## T10/07-157 revision 3

From: George Penokie (IBM)

Subject: SAM-4: Changes requested from 03/2007 editing session

During the SAM-4 editing session in March it was requested that the UML diagrams be enhanced to include all the parameters that are listed in the Execute Command procedure call and to add in associations between some of the classes in the SCSI initiator device and the logical unit class diagrams. This proposal makes those changes.

Figure 2 — SCSI Domain class diagram overview

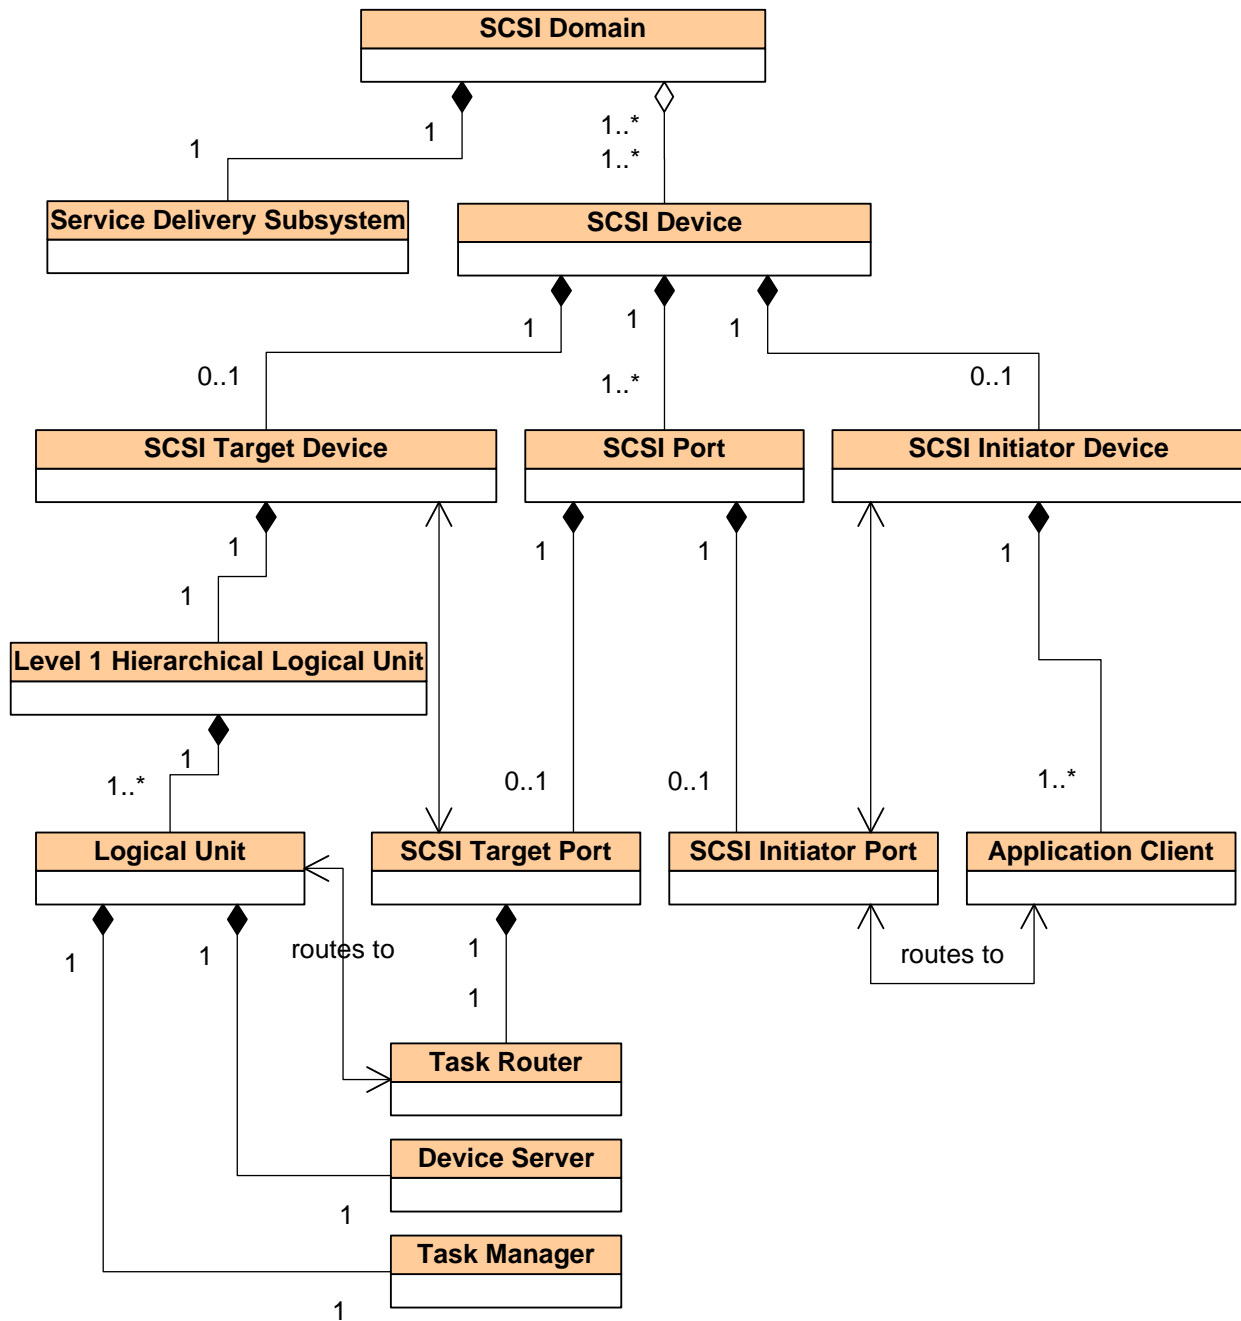
Figure 2 shows the main functional classes of the SCSI domain. This standard defines these classes in greater detail.

Figure 3 — SCSI Port class diagram

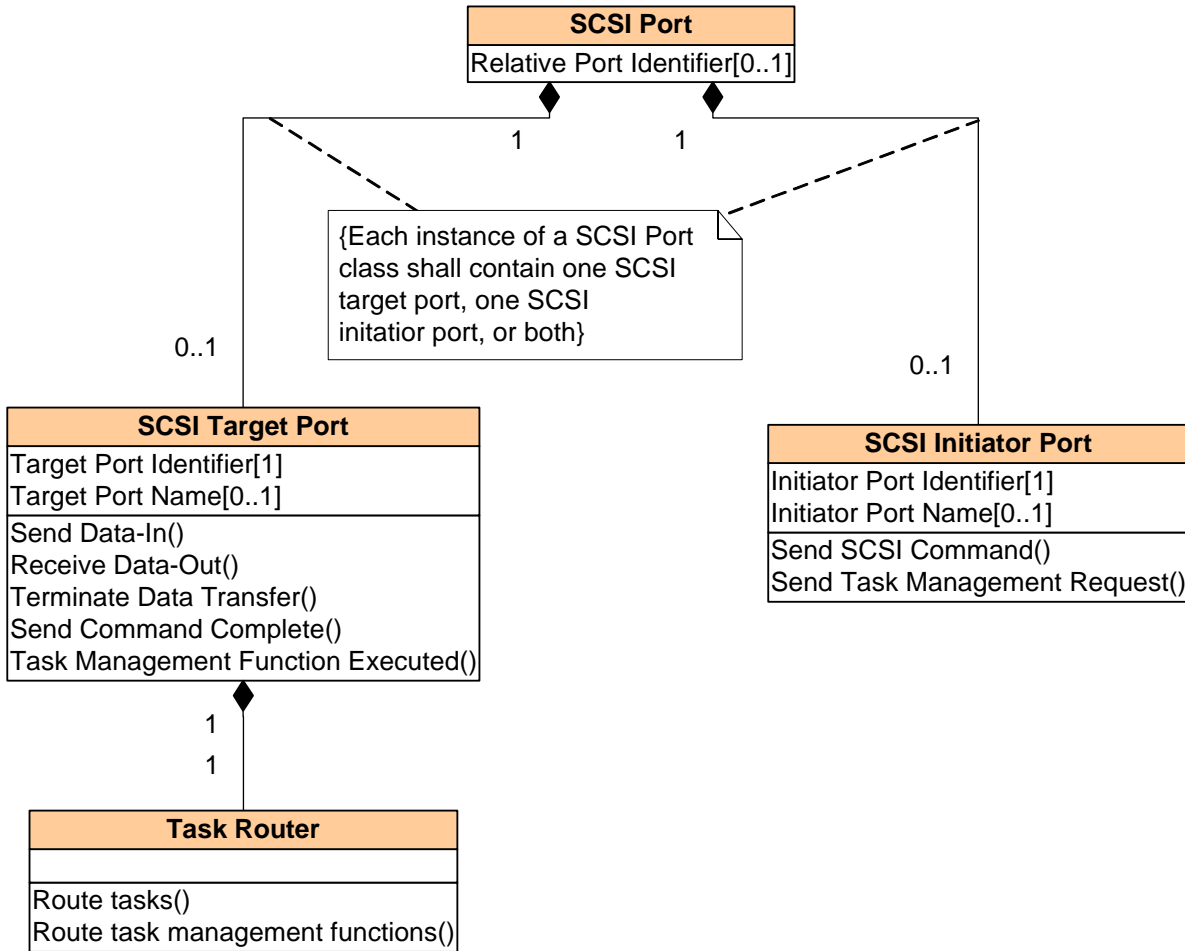
A The SCSI Port class (see figure 3) contains the:

- a) SCSI Target Port class (see 4.4.3) ~~that contains the:~~  
A) Task Router class (see 4.4.5);
- b) SCSI Initiator Port class (see 4.4.4.1); or
- c) both.

Figure 4 — SCSI initiator device class diagram

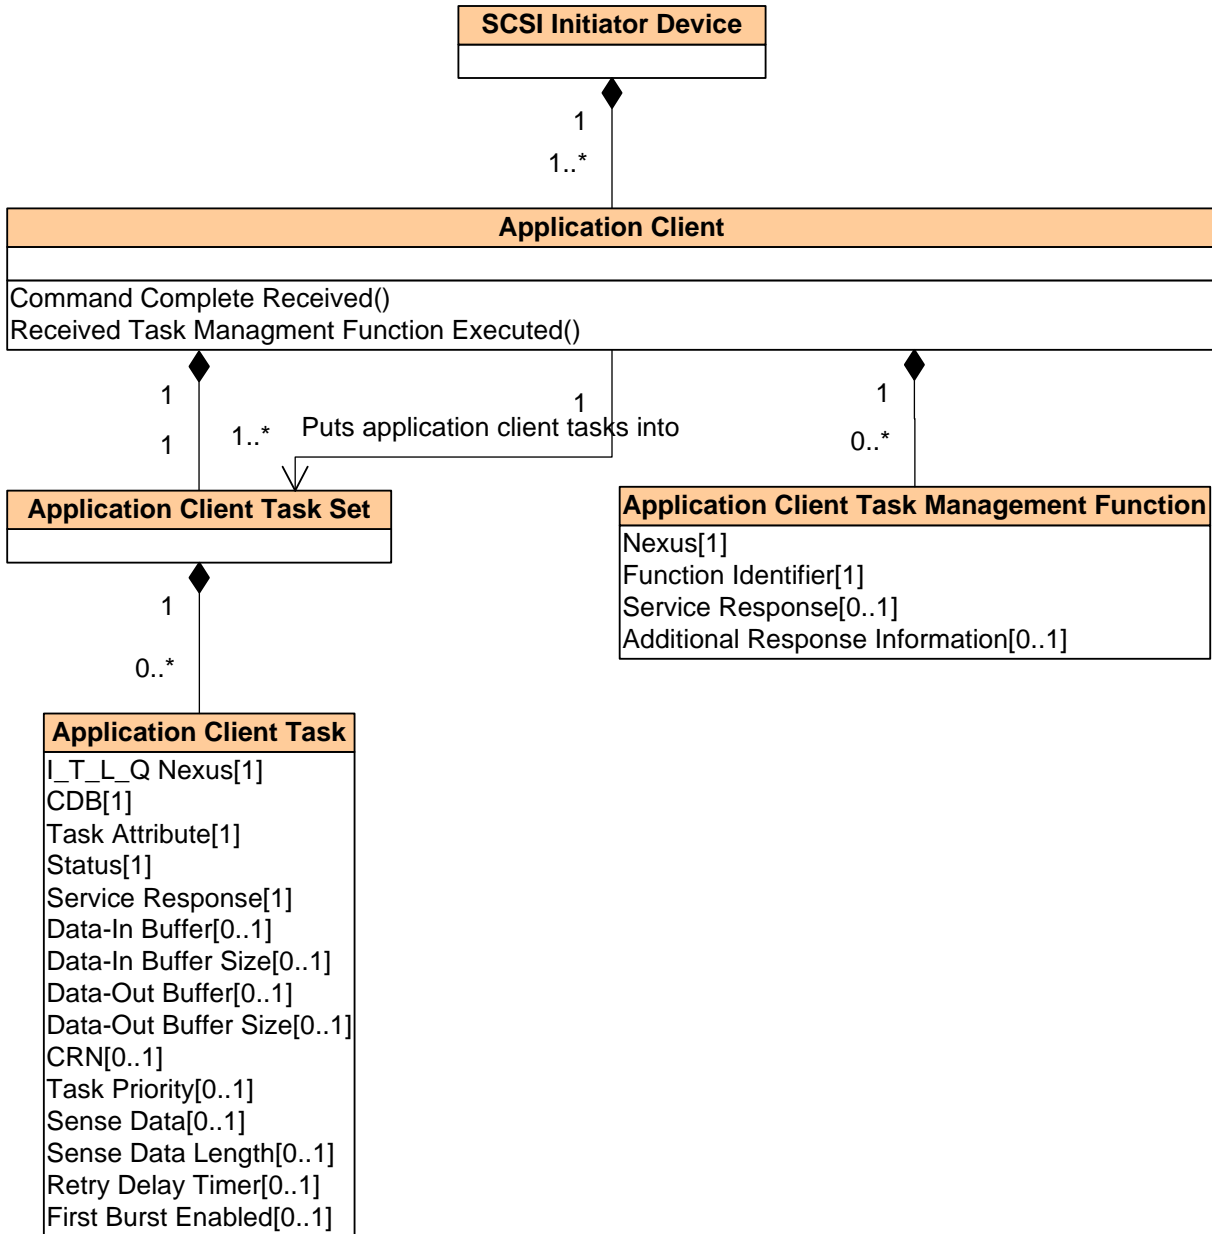
[The SCSI Initiator Device class \(see figure 4\) is a SCSI Device class that contains the:](#)

- a) [Application Client class \(see 4.5.10\).](#)
- a) ~~A SCSI initiator device class (see figure 19) is a SCSI device class that contains the:~~
  - A) ~~Application Client class (see 4.5.10) that contains the:~~ and:
  - B) ~~application client task class.~~

Figure 5 — Logical unit class diagram

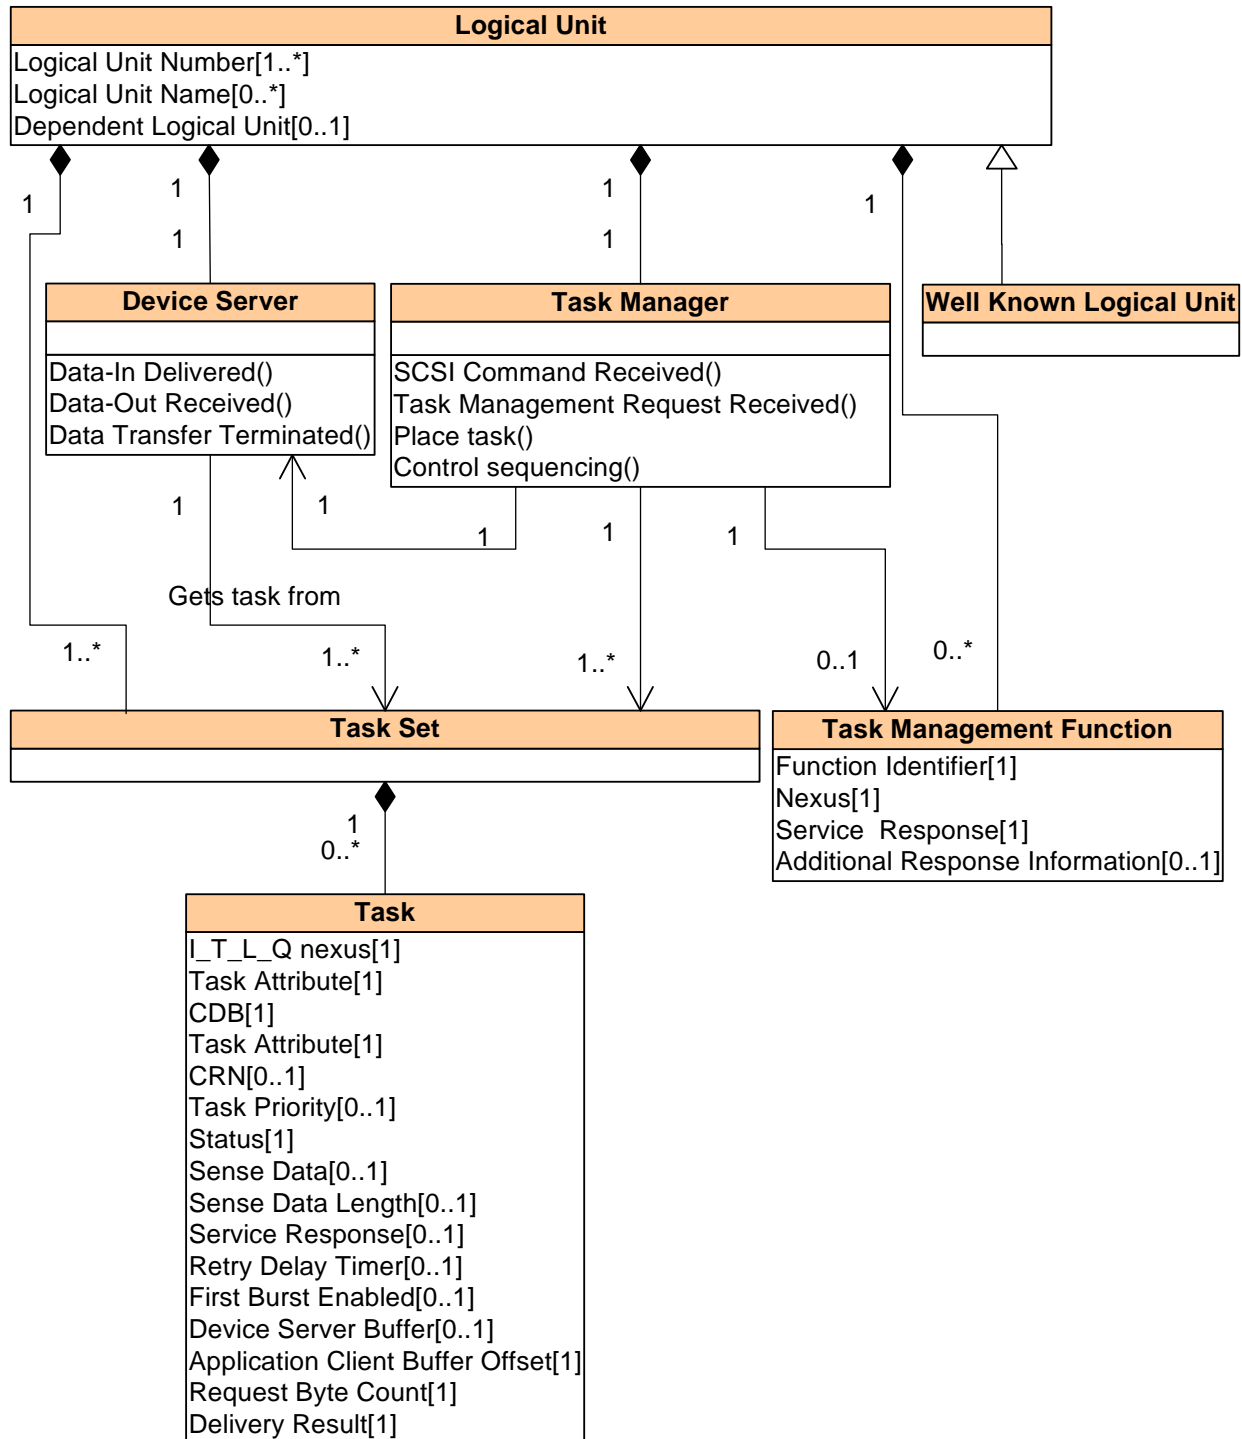
**A** The Logical Unit class (see figure 5) contains the:

**A** The Logical Unit class (see figure 5) may be substituted with the:

- a) Well Known Logical Unit class (see 4.5.24.1); or
- b) Hierarchical Logical Unit class.
